JOSEPH M. FARLEY NUCLEAR UNIT
NURC 55.0

ENVIRONMENTAL QUALIFICATION REPORT EVALUATION # 296

Equipment Description Raychem/CHICO Equipment Entrance Seal (See Note 4) Attachment 13 thru 15
 Manufacturer Raychem and Crouse-Hinds Model/Serial No. Raychem NCE with CHICO-A
 Qualifier (Test Lab) Raychem/Bechtel/SvRI Note 2 (S-492-2) (C03-4974-001)
 Reported by Robert A. Frink Report No. (S-15W) (E) EDR-504C
 Title Senior Engineer Date 9/8/87

Raychem/CHICO Equip
Entrance Seal

Fig. 1: NCBK Configuration
Qualified By Ref. (A) Wyle
Test Report 5844 2-2

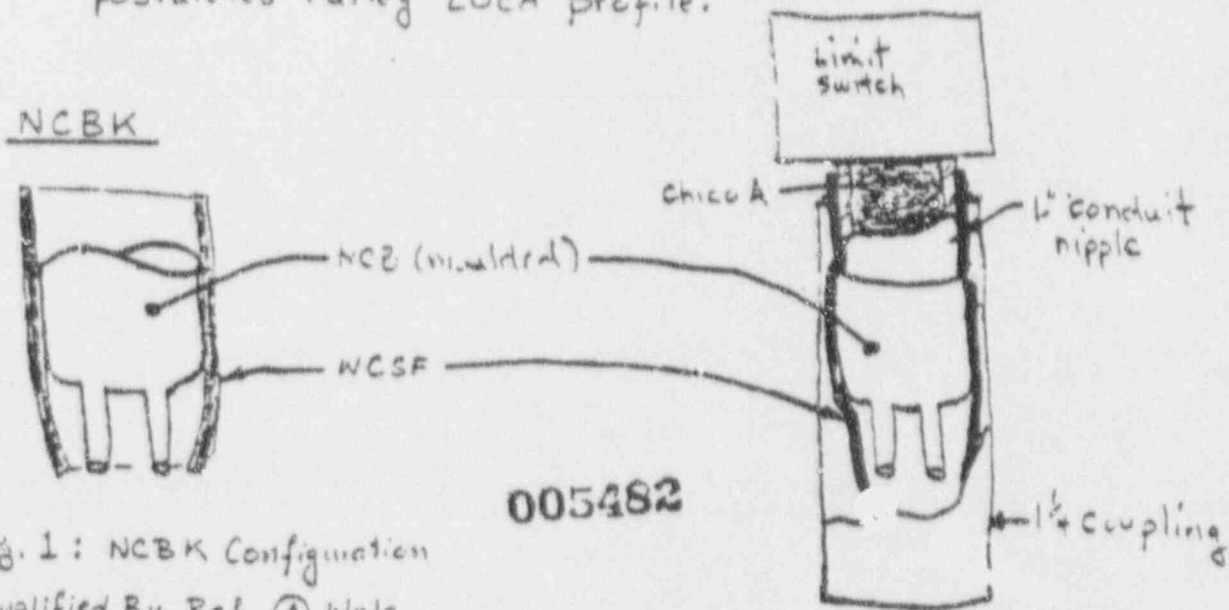
1. Qualification of the Raychem/Crouse Hinds (CHICO) environmental seal is based on similarity to the NCBK (Fig. 1) by use of the NCB molded boot breakout with the WCSF insulated sleeve. This NCB molded boot is qualified with the WCSF insulating sleeve per Wyle Lab Test Report 5844. The Raychem/Chico environmental entrance seal is similar to the tested WCSF/NCB in that the WCSF sleeve is now surrounded by a 1/4 inch metal coupling. In addition, the NCB is attached to a 1 inch conduit nipple which is filled with CHICO sealing compound to provide structural support for harsh environment. Since the NCBK had been qualified previously Ref. (A) tested the CHICO environmental seal configuration (Fig. 2) for postulated Farley LOCA profile.

3. The ^{Raychem/}CHICO seal configuration (Note 1, Fig. 2) that was tested consisted of a 1" nipple (conduit), a 1/4" pipe coupling, a Raychem NCB, a Raychem WCSF sleeve and the CHICO AA (Ref. ② sec. V, App. A sec. III, IV & App. B). Testing per Ref. ② did not test to the extremes of the DBE (Specified 316°F, tested 310°F). However, the metal pipe will withstand the DBE extremes; the NCBK was tested to the DBE conditions (Ref. ②) and the CHICO is a cement mixture of calcium aluminate and gypsum cement (Attachment 2) inside the conduit (Note 1). In addition, the CHICO-A withstood the pressure test, via the NCBK, with 12 psig margin (Attachment 1 p. 2).

EQREC #296
COMPOSITE LOCA/MSLB
CONTAINMENT PRESSURE ENVELOPE

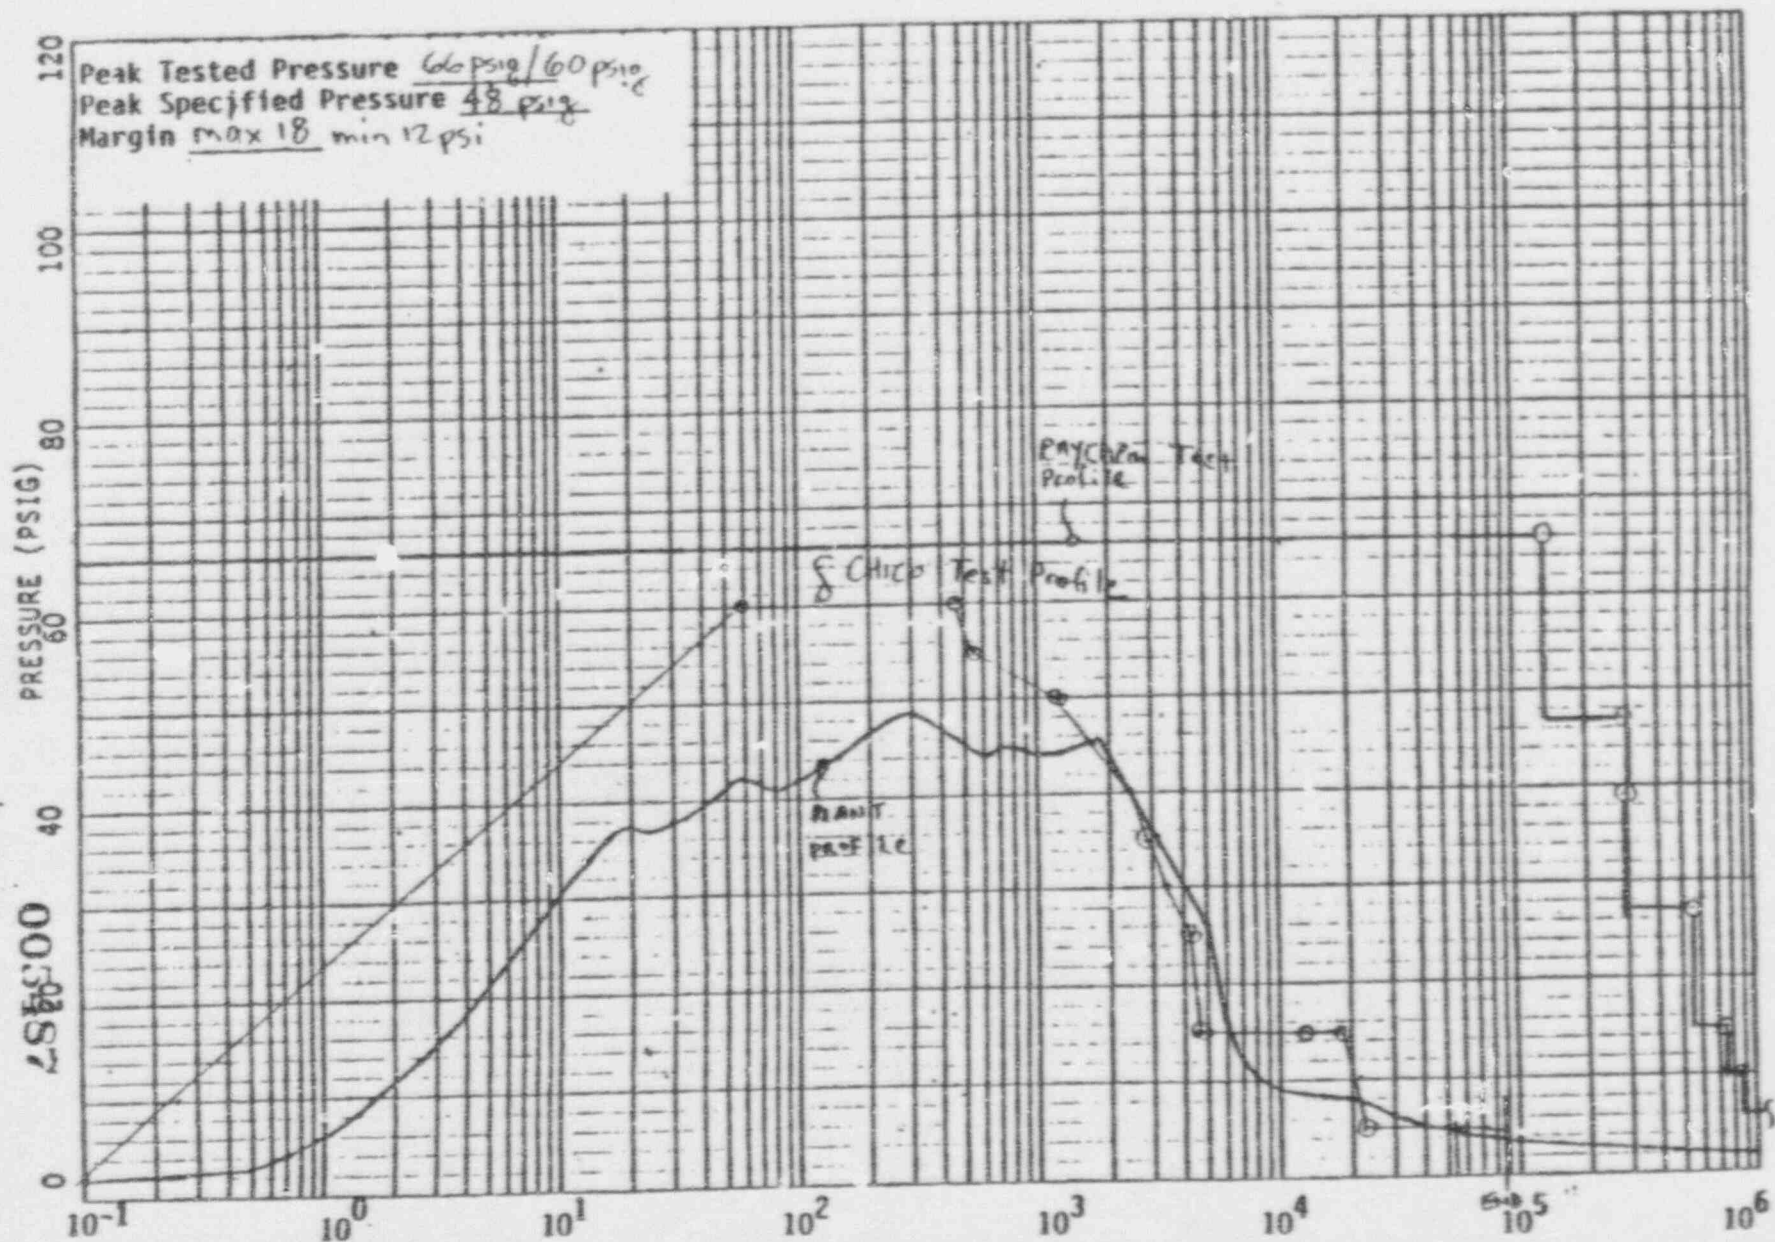
FAULTY REQUIREMENT	QUALIFICATION	TOTAL MARGIN
TEMPERATURE	316 °F	Ⓐ 390 °F Ⓑ 310 °F See EDRECH Note 3	74 °F (23%)
PRESSURE	62.7 psia = 48.0 psig FOR APPROX. 60 SEC. (COMPOSITE PROFILE FOR LOCA & MSLB)	Ⓐ 60. psig Ⓑ 60 psig	Ⓐ 18 psig (37.5%) Note 1 Ⓑ 12 psig (25%)
RADIATION	5×10^7 rads (TID)	Ⓐ 20×10^7 rads Ⓑ 10.2×10^7 rads	Ⓐ 15×10^7 rads (300%) Ⓑ 5.2×10^7 rads (104%)
VOLTAGE	600 V	100 V rms	Ⓐ 400 V (66.7%)
FREQUENCY	N/A		Frequency variation will not affect function
OPERATING TIME + 1 HOUR	720 hrs + 1 hrs	Ⓐ 720 hrs + submergence test

Note 1: The pressure margin exceeded the required 10 psi margin, but the test chamber maintained saturated conditions throughout the test.

SUMMARY: Margins are acceptable

FIGURE 1

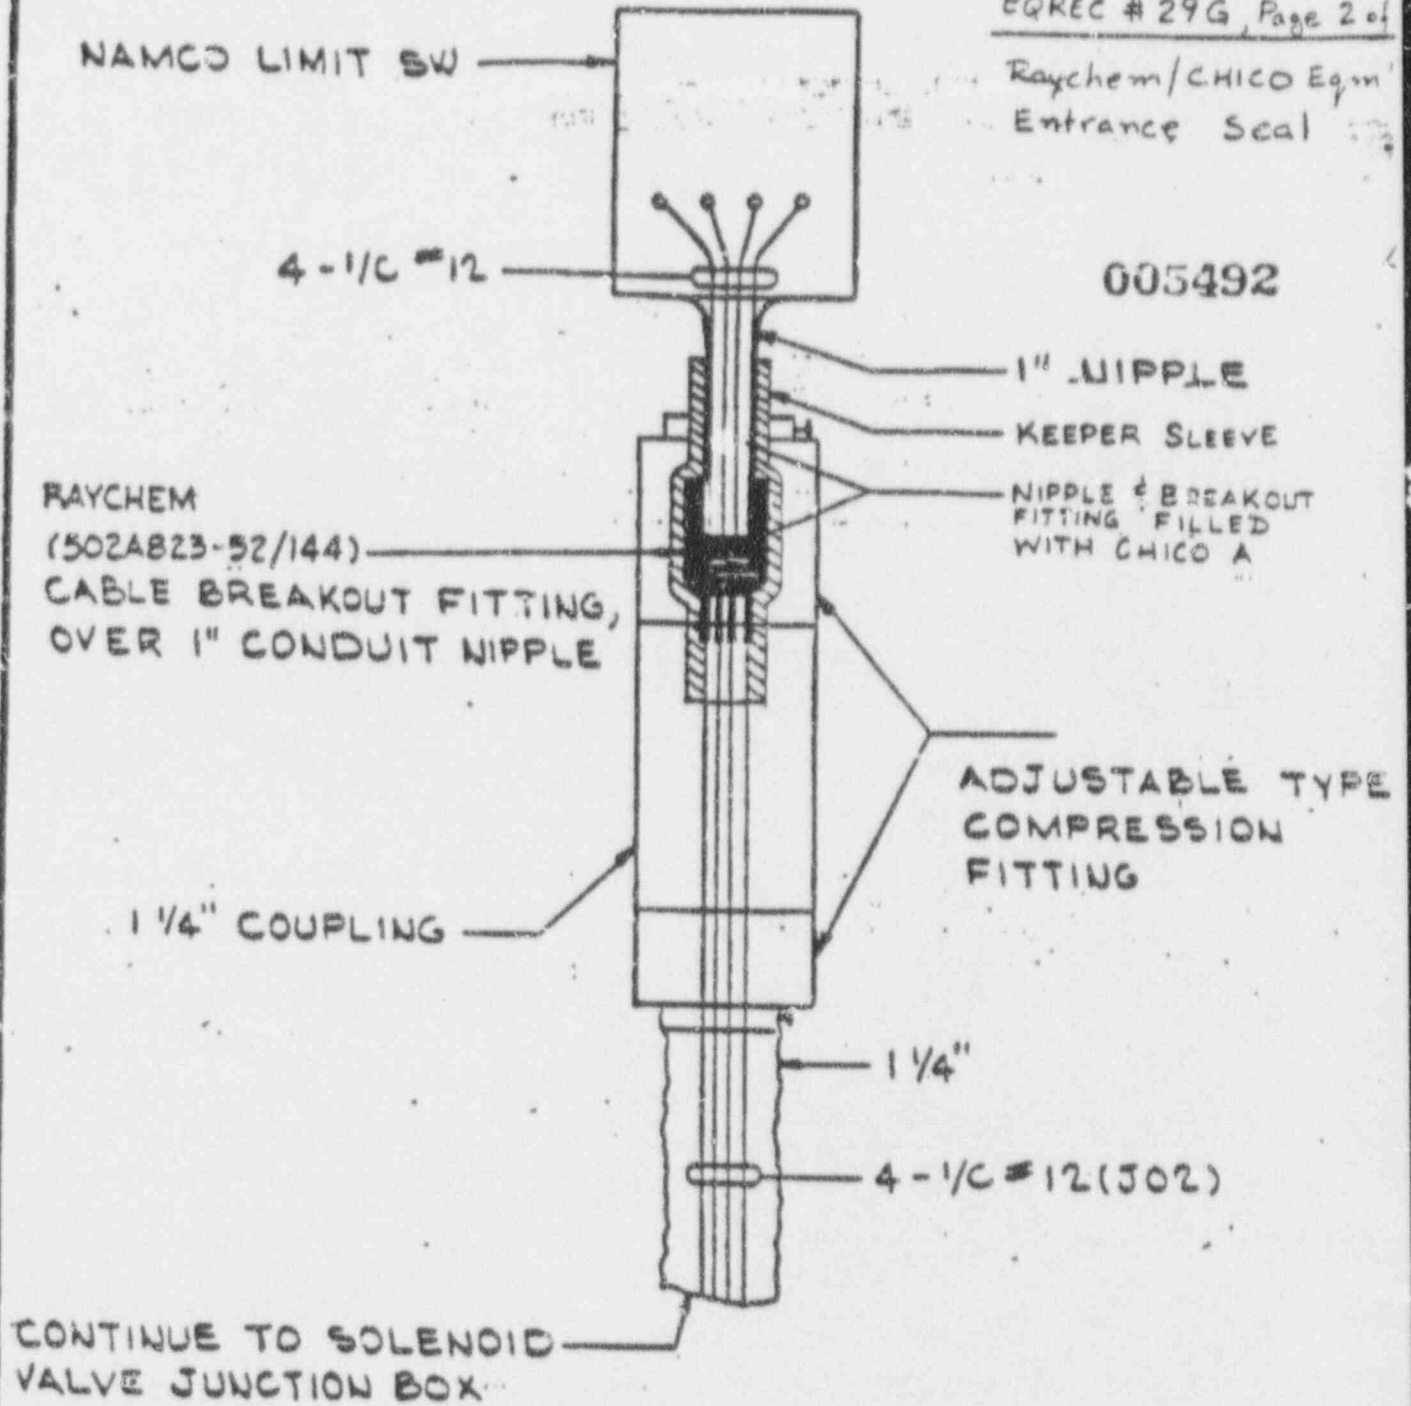
The environmental seals used with NAMCO EA-180 limit switches are composed of a Raychem WCSF breakout boot that has been shrunk onto a 1" pipe nipple attached to the limit switch (See Figure 1). The individual conductors connected to the switch pass through the breakout boot which forms a seal to the conductor insulation/jacket. To provide mechanical rigidity to the breakout boot, the nipple and the breakout boot are filled with Crucse-Hinds sealing compound (CHICO A) and allowed to cure. In addition to providing mechanical rigidity to the breakout boot crotch, the CHICO A provides an additional pressure tight barrier (seal) inside the pipe nipple which is environmentally qualified. CHICO A was qualified by test conducted by Southwest Research Institute (SWRI Project No. 03-4974-001) for use as drywell penetrations for Grand Gulf Nuclear Station. In addition, on the recommendation of Raychem, a keeper sleeve was installed over the breakout boot and the nipple to add rigidity to the boot, and to keep the boot in place during elevated accident temperatures when the adhesive softens.

The zinc coating on the galvanized steel nipple may react with the chemical spray during LOCA and form a grey product over the nipple. However, the chemical spray does not react with the Raychem S1119 adhesive (Reference Wyle Test Report no. 58442-2, Section 3.4, Page 9 and Section 3.4.2). In addition the duration of spray at Farley is only 87 minutes and the individual conductors will be effectively shielded from the spray.

Should there be a failure of the adhesive between the pipe nipple and the breakout boot, for whatever reason, the seal assembly would remain intact because of the keeper sleeve and the clamping action of the compression adapter. If it is postulated that the breakout boot, the keeper sleeve and the compression adapter clamp all fail, the internals of the NAMCO limit switch will still be protected by the approximately 3 inch long CHICO A seal.

MSLB INSIDE MAIN STEAM ROOM
TEMPERATURE ENVELOPE

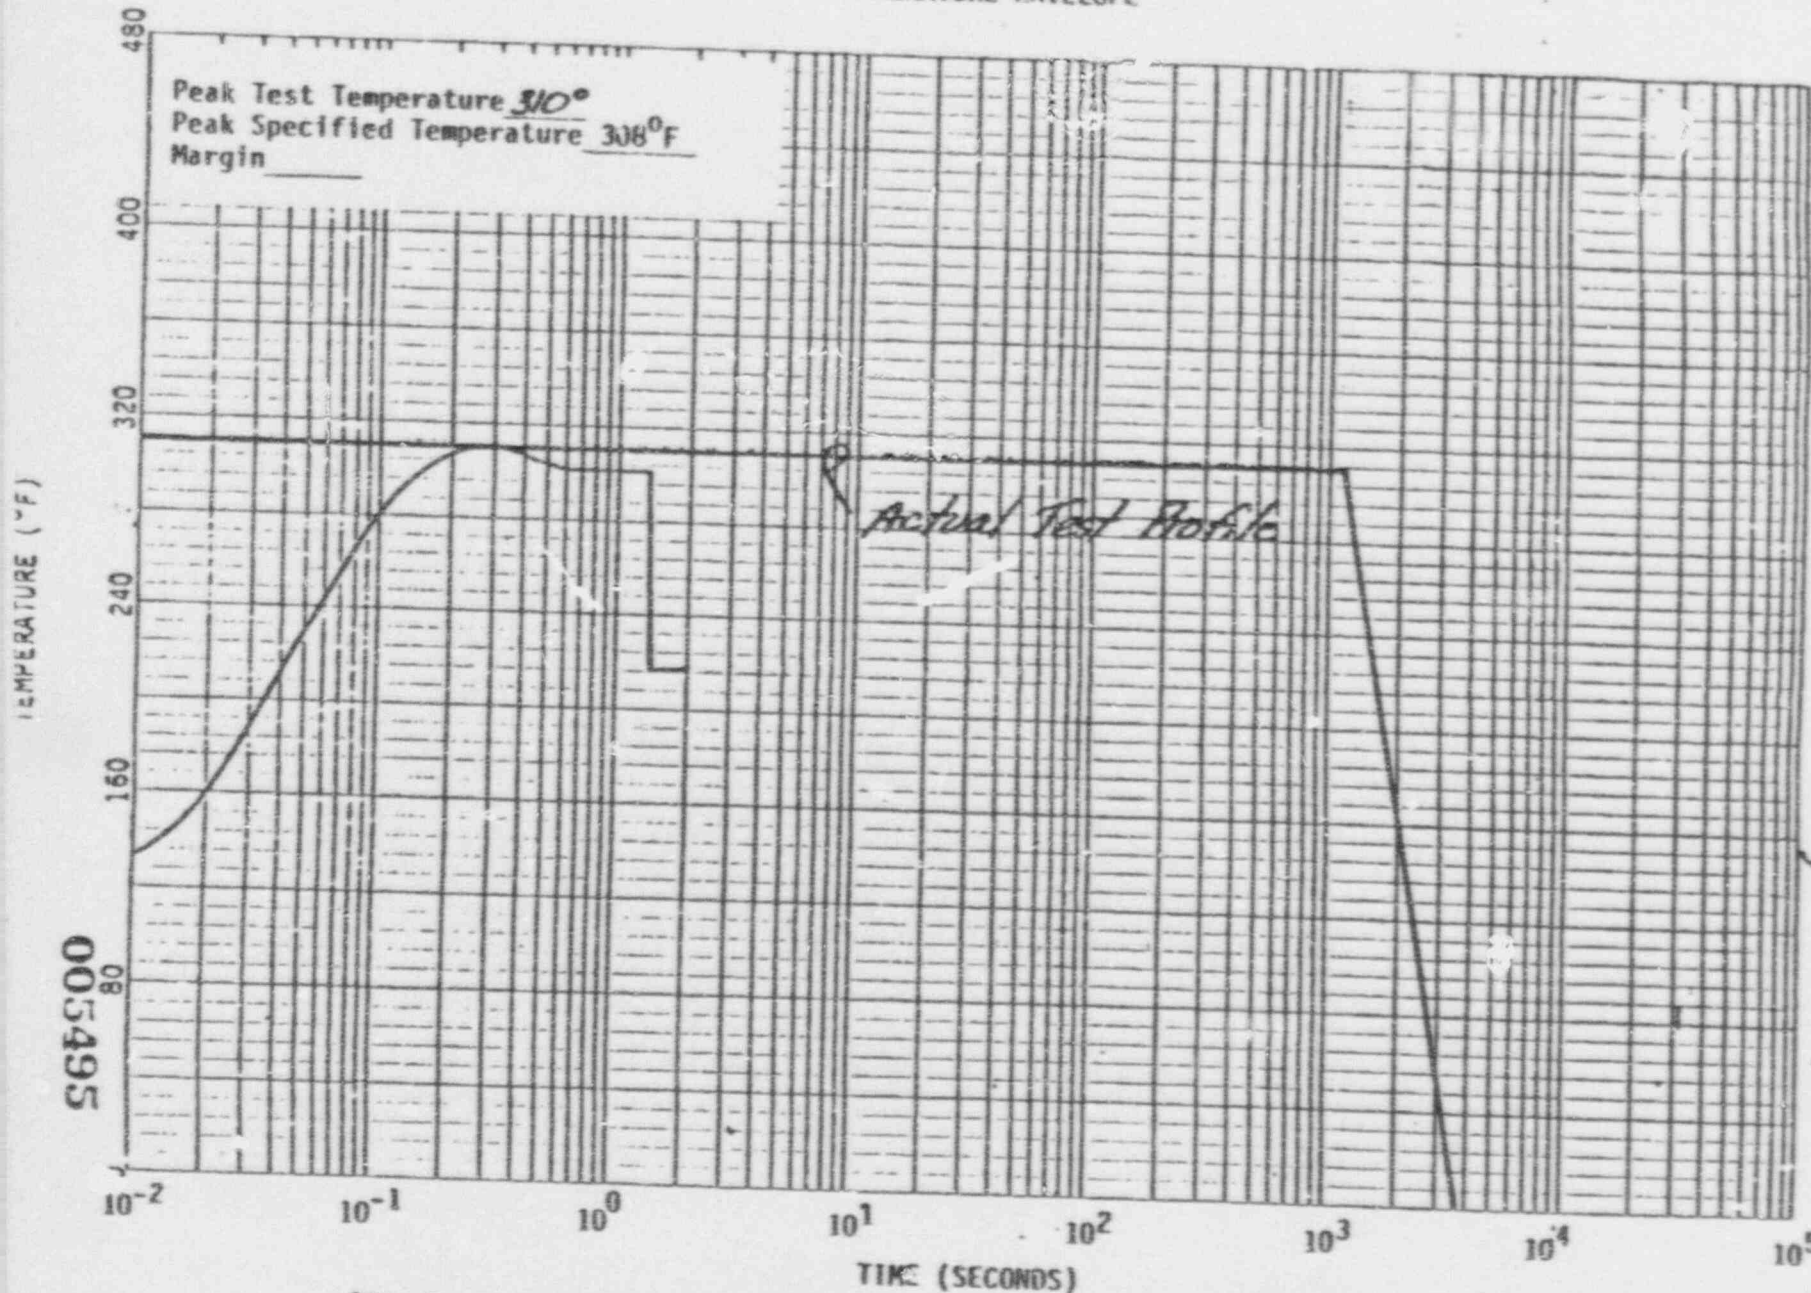
The use of the Chico sealing compound is not required for use in the main steam valve room because of the low pressure peak (5.8 psig) and the short duration of the transient (1.5 sec). As can be seen from attachment 1, pages 1 and 2 of this addendum, the MSLB on the MSR accident profiles are enveloped with considerable margin.

The actual test transient was started when the chamber temperature reached 310°F and the pressure quickly rained to 50 psig. After 7 minutes, the pressure was reduced to 45 psig. After 17 minutes into the test, the seal ruptured.

Because the environmental parameters were exceeded for a time duration several orders of magnitude beyond the required time, the Raychem breakout seal configuration without Chico A is qualified for this application.
